COUNCIL ASSESSMENT REPORT

Panel Reference	PPSSSNH-729
DA Number	eDA0485/25
LGA	Ku-ring-gai
Proposed Development	Construction of a residential flat building, basement carparking and associated works.
Street Address	46-50 Cown Road, St Ives
Applicant	Traders in Purple
Date of DA lodgement	09/09/2025
Total number of Submissions Number of Unique Objections	16 unique objections
Recommendation	Refusal
Regional Development Criteria: Schedule 6 of the SEPP (Planning Systems) 2021	Estimated development cost of greater than \$30 million
List of all relevant s4.15(1)(a) matters	• Environmental Planning and Assessment Act 1979 • Environmental Planning and Assessment Regulation 2021 • Environmental Planning and Assessment (Savings, Transitional and Other Provisions) Regulation 2017 • State Environmental Planning Policy (Resilience and Hazards) 2021 • State Environmental Planning Policy (Sustainable Buildings) 2022 • State Environmental Planning Policy (Housing) 2021 • Ku-ring-gai Local Environmental Plan 2015 • Ku-ring-gai Development Control Plan

To determine Development Application No. eDA0485/25 for construction of a residential flat building, basement carparking and associated works.

See below marked up encroachment into TPZ of T25:

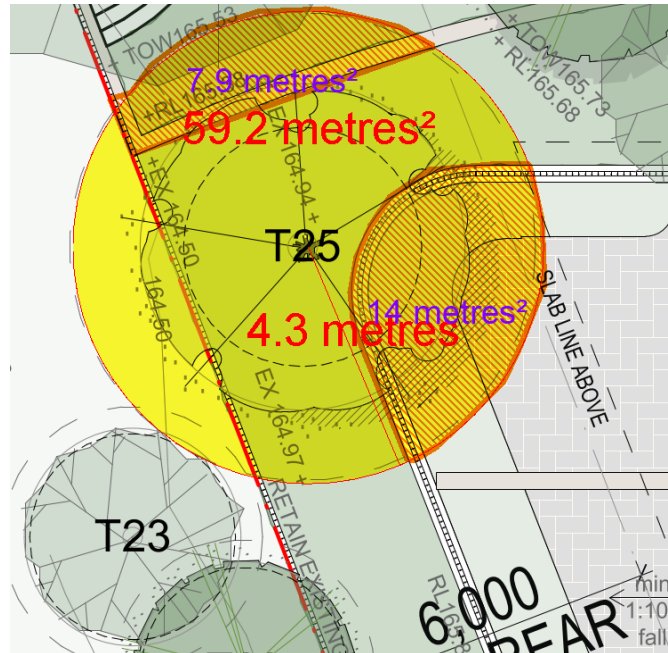
- The proposed retaining wall and fence around terrace of unit ALG.01 will encroach into the TPZ by 21.9m² (37%) and into the structural root zone (SRZ) by 20% which is a major encroachment under AS4970-2025.
- Amended plans will be required to reduce the encroachment to an acceptable level. This will require the relocation/redesign of the proposed retaining walls and private open space of Unit ALG.01 to reduce the excavation to no more than 10% of the TPZ to retain this tree.

- The submitted AIA does not identify the proposed works in the ground level as an impact on this tree.

Figure 2: Example of the potential location of visitor bicycle parking.

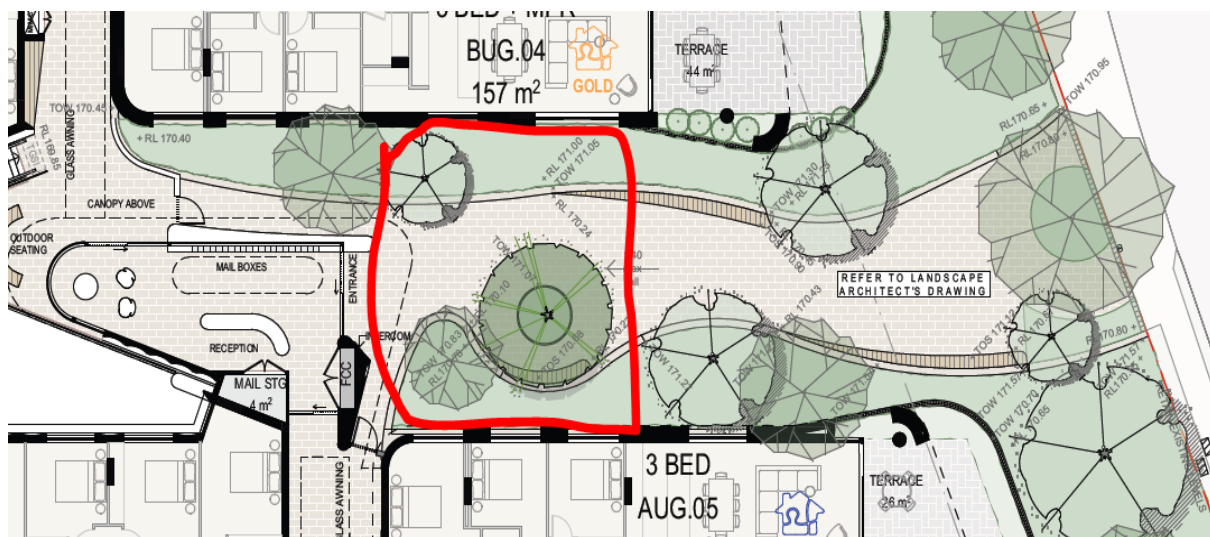
*Bicycle parking for visitors is planned to be located on the Cowan Road frontage, between the access point and the southern boundary of the site. This location is considered to offer inadequate passive surveillance. To achieve consistency with Security Level C in AS2890.1, facilities should be located in well-lit areas, where passive surveillance is likely, and as close as practicable to the user's destination. Therefore, it is recommended that the visitor bicycle parking be located within the main/central pedestrian entrance from Cowan Road and close to the lobby, for maximum casual surveillance for example the area marked in red in **Figure 2** below.*

Figure 3: Red outline shows planting within the site lines.

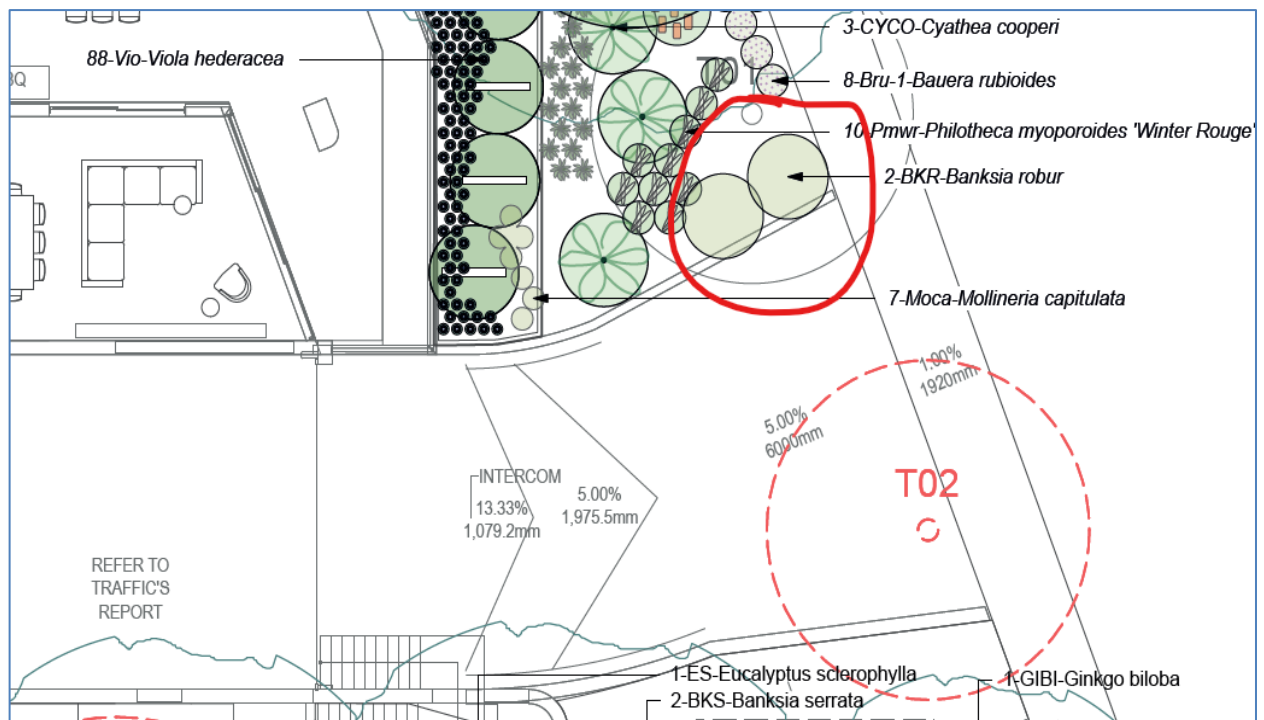
The architectural plans outline the 2.5 metres x 2 metres pedestrian sight triangle on both sides of the driveway, but the landscape plan indicates planting in this area. See the below figure for more details

Clarification is needed the planting would not impact on sight lines.

Figure 5: Lower Ground Floor GFA calculations (orange highlights depicts additional GFA)

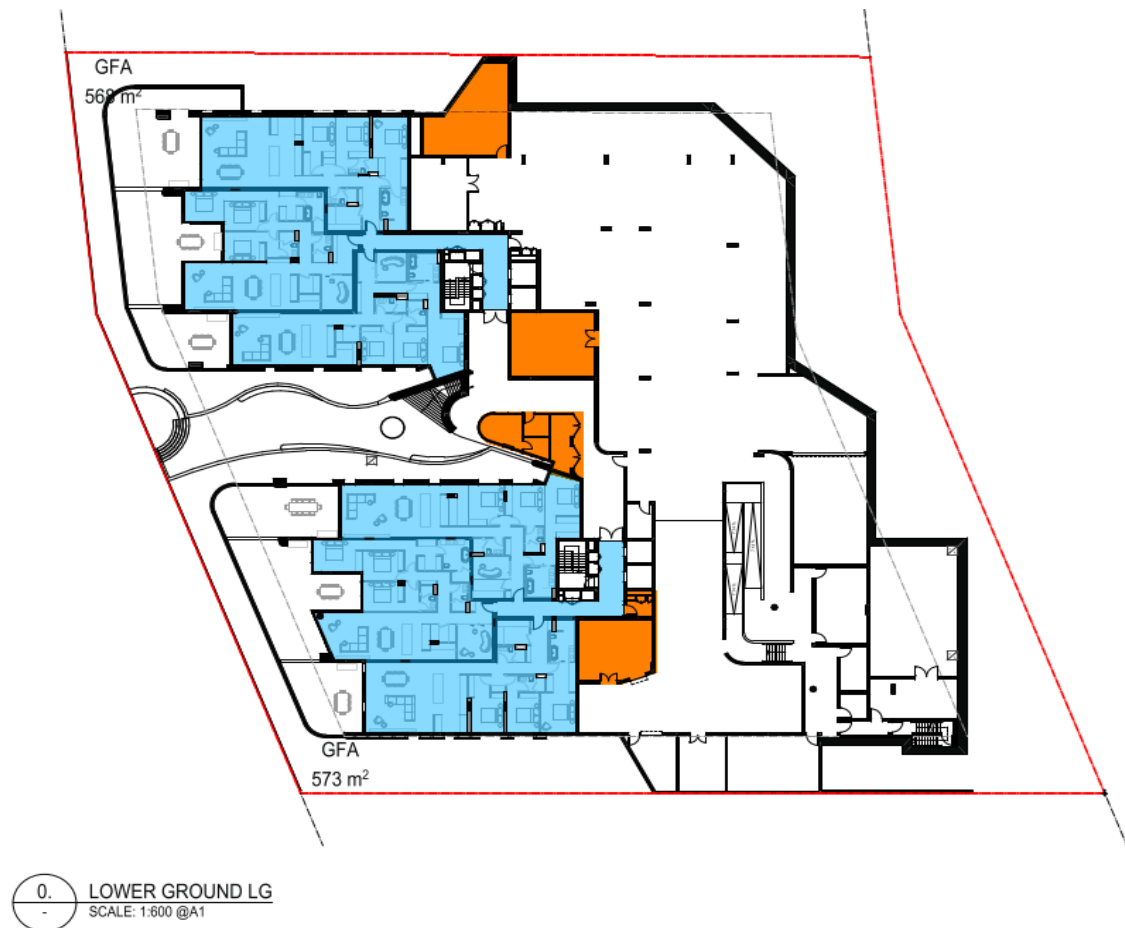
Contrary to the applicant's claim, the proposal exceeds the maximum permissible floor space ratio (FSR) for the site. This is based on the additional highlighted areas (in orange) illustrated above in **Figure 5**, which were not included in the FSR calculation. Further information in the form of an additional section plan is required in order to determine the extent of additional gross floor area. This issue forms Reason for Refusal No. 5.
